**CITY OF TEMPE
REQUEST FOR COUNCIL ACTION**

**Meeting Date: 09/22/2016
Agenda Item: 6B4**

ACTION: Introduce and hold the first public hearing to adopt an Amended Planned Area Development Overlay and Development Plan Review for two new 24-story buildings consisting of a mixed-use 586-unit multi-family with retail and restaurant uses for THE PIER, located at 1190 East Vista Del Lago Drive. The applicant is Sender Associates Chtd. The second and final public hearing is scheduled for October 27, 2016. (Ordinance No. O2016.55)

BACKGROUND INFORMATION: THE PIER (PL160248) is located on the south side of Tempe Town Lake, west of Tempe Marketplace, east of Arizona State University within an original Planned Area Development approved in 2007 and an amended PAD approved in January 2016. The development was subdivided and street improvements installed; the lots have remained undeveloped. Lot 5 of the development was originally proposed for a hotel use, the most recent approval was to allow 551 units within a new mixed-use development of residential, retail and restaurant uses along the lakefront. A pedestrian tract to the east would be developed by the owner of the lot to the east, and the

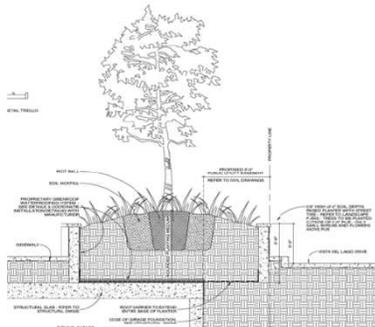
The proposed 1,061 parking spaces may require further reduction due to landscape requirements on the street front. There is a requirement for street trees outside of the Public Utility Easement (PUE) and 20' from water utilities and hydrants. The proposed underground garage leaves limited surface soil on site for trees. The original Planned Area Development had 39% landscape area and 14 Velvet Ash street trees lining the north side of Vista Del Lago Drive. With the current layout, the 11% landscape area has all trees on site in containers, limiting their size, structural stability and longevity. Staff previously identified 8 tree locations as a compromise to the approved 14, although the plans only showed 6 street trees (four of these clustered in shared containers), the remainder were palms in the January entitlement.

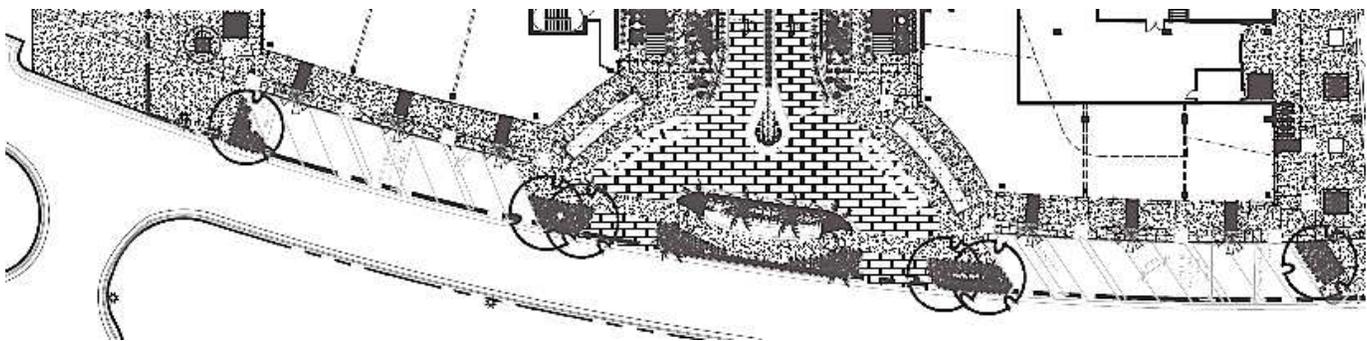
The proposed design solution (Attachment 44) is shown below. The tree planters are adjacent to the public utility easement and provide approximately 4.5' of soil depth (2 feet below grade) in planters approximately 9 feet wide by 9 feet long (5 feet of the planter box is over the public utility easement, requiring a root barrier). This solution would provide limited soil for a tree to grow. Until the understory plants mature, the mounded soil would potentially wash out during heavy rains. The trees would be limited in root area and require replanting prior to maturity, always appearing as a newly planted tree.

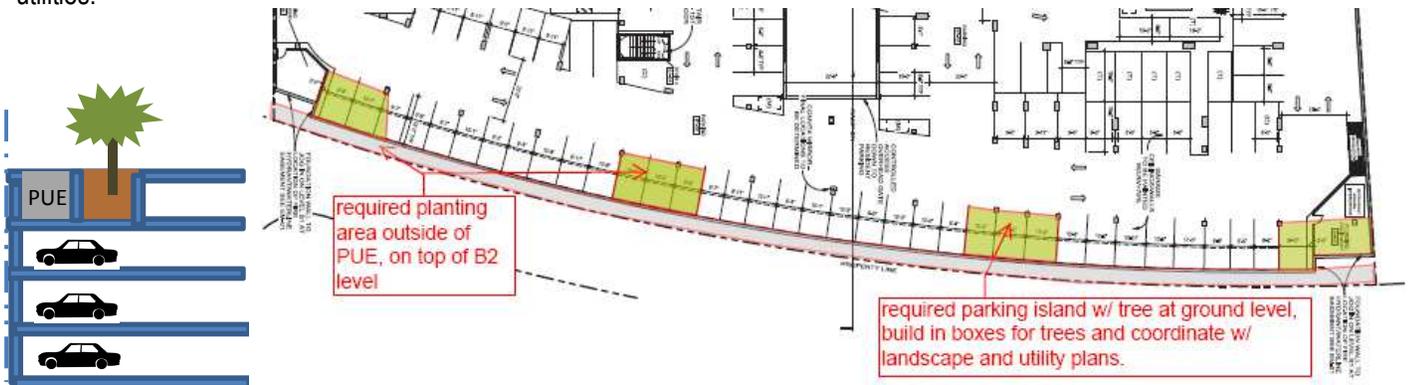
There is a condition of approval which would potentially impact 10 parking spaces located on the south side of Level B-1 in the garage, reducing the parking to 1,051 spaces. This reduction would allow street trees to be planted in a larger soil base, with approximately 18'x17' of

surface area and 9' of soil depth, creating built in planters the full depth of the first floor of the garage, rather than the 4 foot root zone proposed in the landscape plan. This solution would require removal of parking spaces on Level B1 of the garage, for recessed (in ground) planters large enough to meet the minimum square footage area to sustain required trees to a mature size.

Below is an illustration of the approximate underground basement level impacts to parking, with the PUE shown in the first 5' as grey. This PUE was reduced from 9' to 5' with engineering approval that no private utilities or trees be located within this area. The green areas are proposed to address requisite street tree planting areas as described below the image. This solution would allow parking spaces between 'planter' walls; subsequent lower floors would retain full use of the area for parking as proposed. Other design solutions may be feasible; therefore the condition supports other solutions that may not have been considered, as long as the public utility easement is maintained in a manner that functions for requisite public utilities.

Since this project has reduced the number of street trees from 14 to 6 (by prior entitlement), staff has kept prior condition #23: Street trees shall be located in ground on the south side of the development along Vista del Lago Drive. These street trees shall be a minimum of 36" box specimens and a minimum of 1 ½" caliper trunk. However, to assure that the design solution meets the intent for sustainable mature shade trees, further specificity is provided to the condition, which is now #26 of this report: Street trees shall be located in ground on the south side of the development along Vista del Lago Drive. These street trees shall be a minimum of 36" box specimens and a minimum of 1 ½" caliper trunk. This requirement would allow the reduction of 10 spaces located on the south side of Level B-1 in the garage, reducing the parking to 1,051 spaces. This reduction would allow street trees to be planted in a larger soil base, creating built in planters the full depth of the first floor of the garage, rather than the 4 foot root zone proposed in the landscape plan. This condition may be modified if an alternative solution is presented to staff that sufficiently meets the intent to sustain mature street trees. .
